ADDENDUM NO.7

DATE: June 14, 2019

PROJECT: Paragould Fire Station #1

ETC Project No.: 15032CPARA

FILENAME:
SHEET
C2

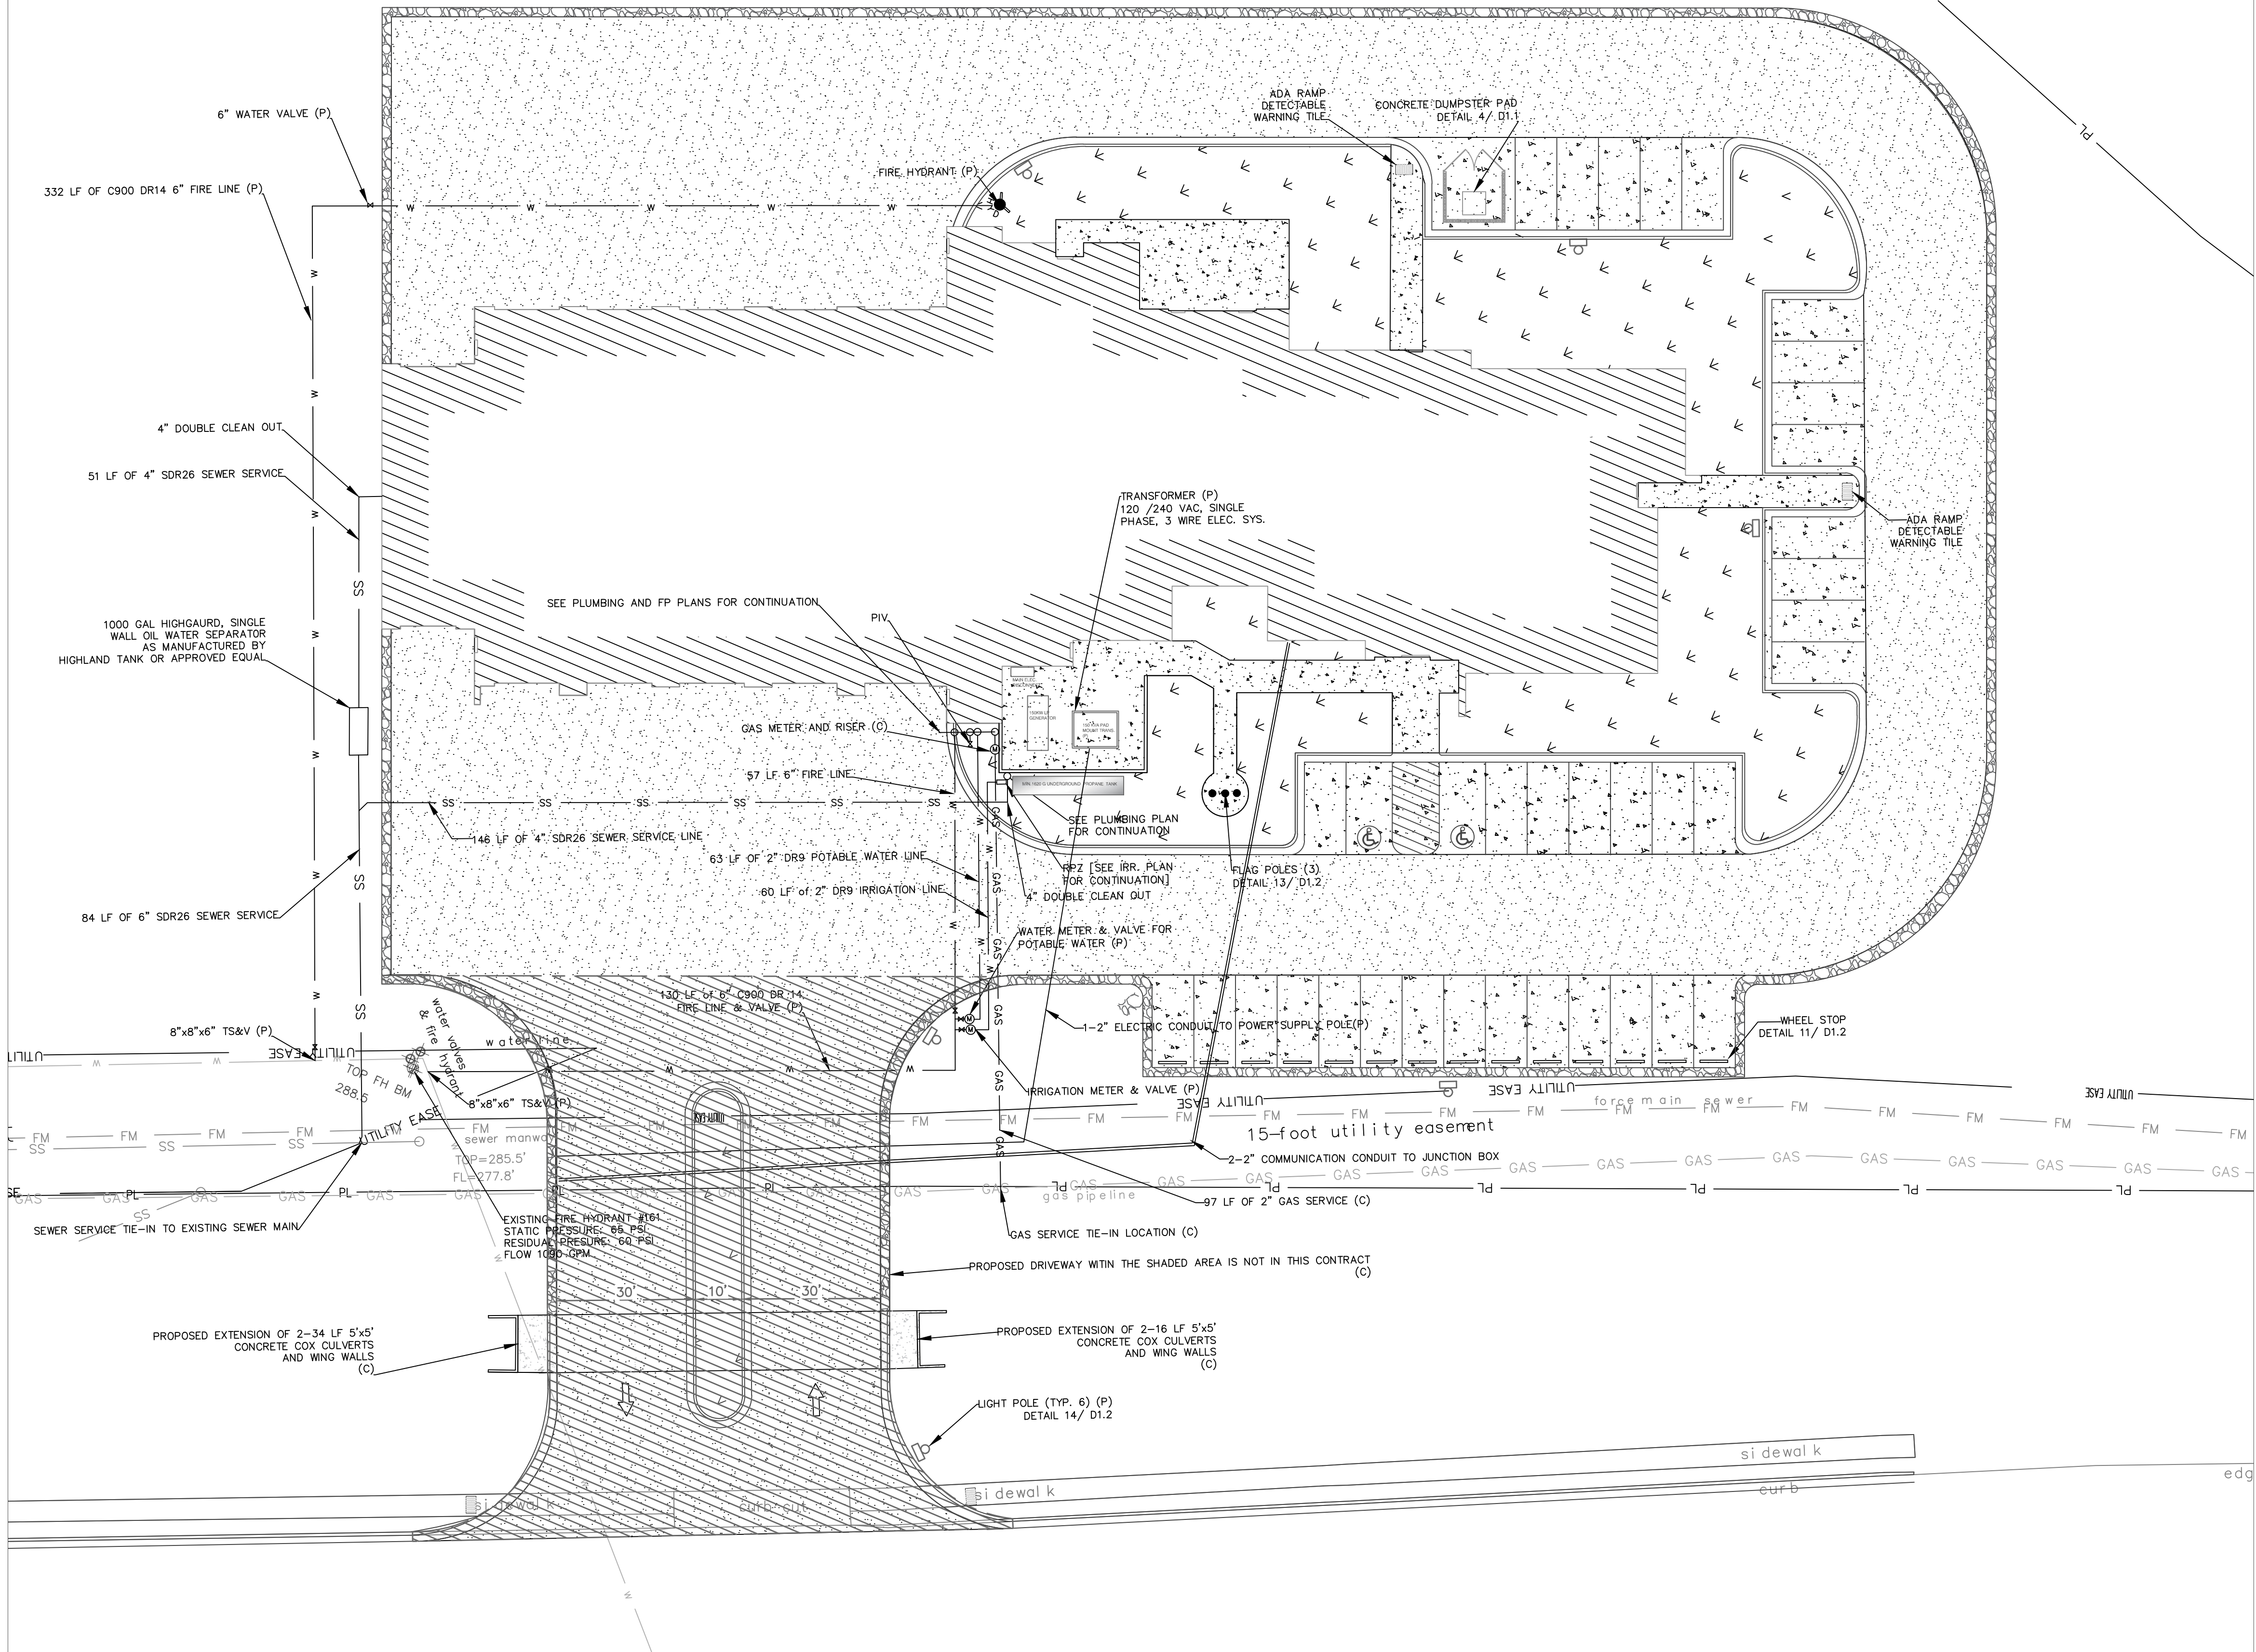
1. Following revisions are made in Sheets C2, C3 & D4. See attached revised sheets:
 - Entire driveway including the extension of existing culverts and related grading in that area are revised and excluded from this bid.
 - On Sheet C2, see the notes "Scope of Work" to identify the work included in the bid.
 - On Sheet D4, Detail AA and Expansion Joint Detail are revised.
2. Add Sheet F1.0 Fire Alarm Plan to the Drawings.

SCOPE OF WORK:

1. (P)= WORK TO BE DONE BY PLWC
2. (C)= WORK TO BE DONE BY OTHERS
